**From:** Leigh Cross s.22(1) Personal and Confidential  
**Sent:** Monday, March 07, 2016 3:05 PM  
**To:** Correspondence Group, City Clerk's Office  
**Subject:** re: 22 East 5th Avenue - heritage designation and Heritage Revitalization Agreement

**With respect to 22 East 5<sup>th</sup> Avenue – Heritage designation and Heritage Revitalization Agreement:**

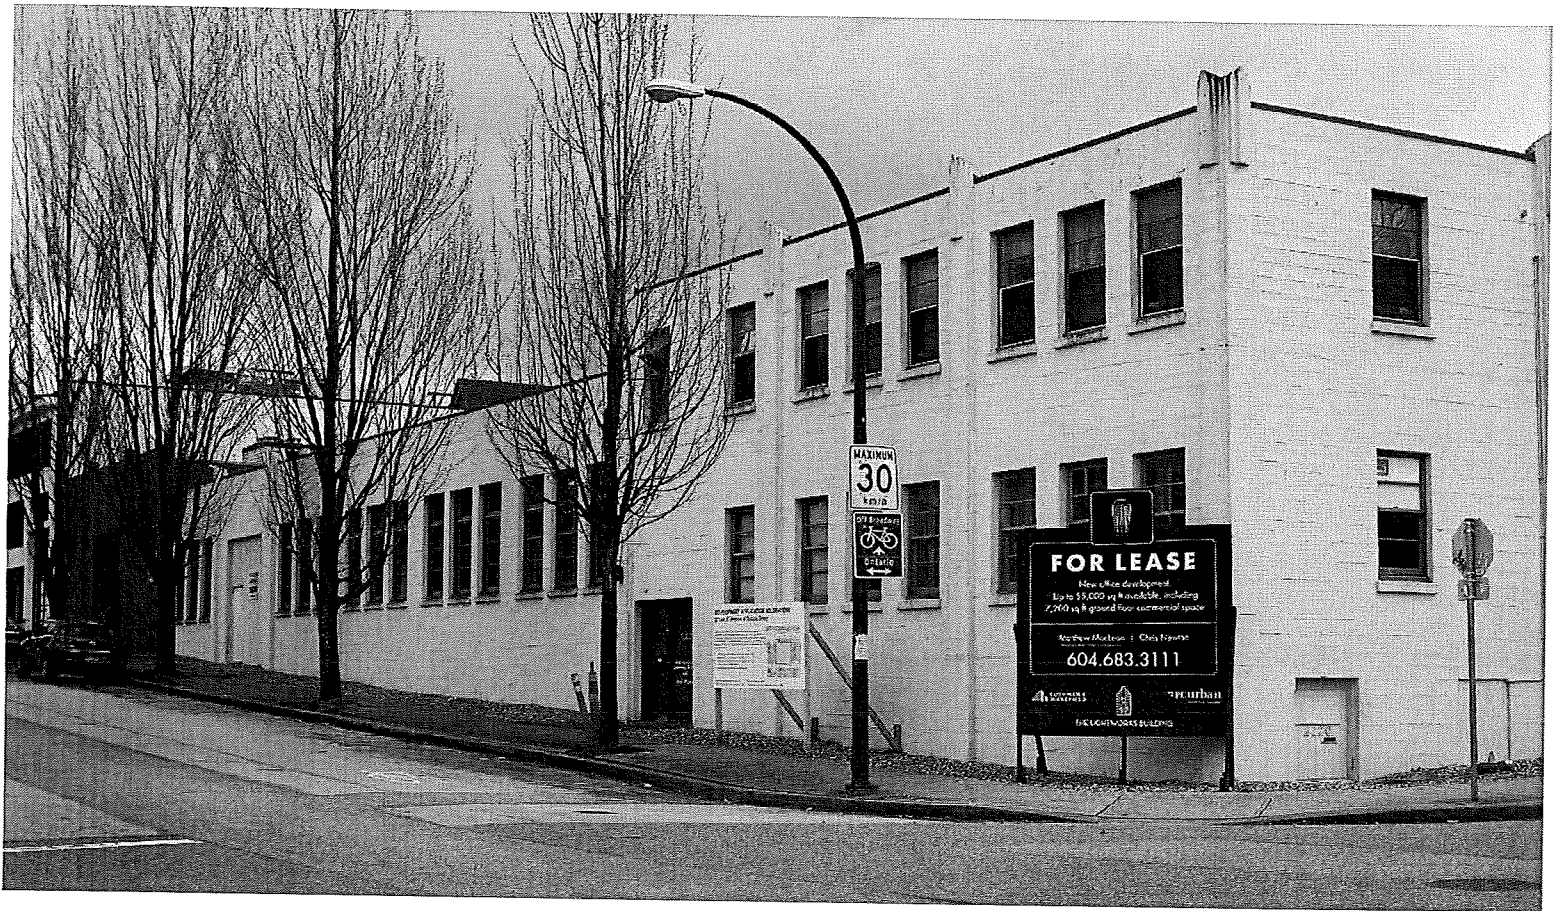
Let me first deal with the existing building. It has very ordinary, factory façades. Only an extraordinarily gymnastic mind could call them "heritage." In DE419206 they are described as "Art Deco." Art Deco? Are they referring to the small concrete excrescences located at the roof line? See the attached photographs.
